**Car Stereo
Service Bulletin**

Model: CDX-7520/-7540/-7560/-7580

No. 197

Subject: Unit Mutes While Making Turns And
During Braking

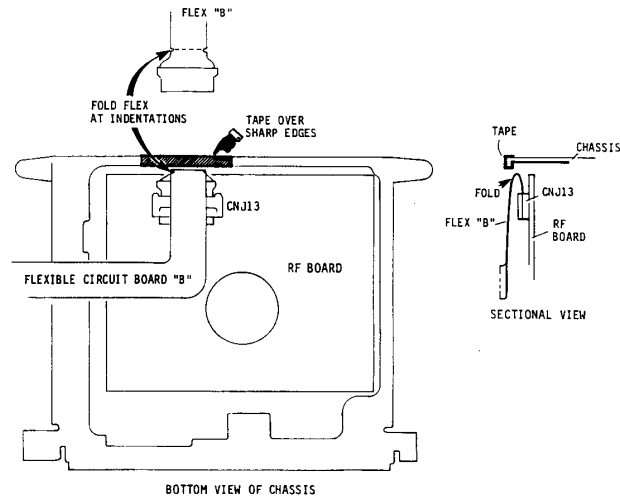
If the unit mutes while making turns or during braking, perform the following procedure:

- Solution:**
1. Install non-woven tape (9mm x 25mm) on the chassis (main) assembly (as shown in the drawing below).
 2. Fold flexible circuit board "B" at indentations towards the inside of the deck.
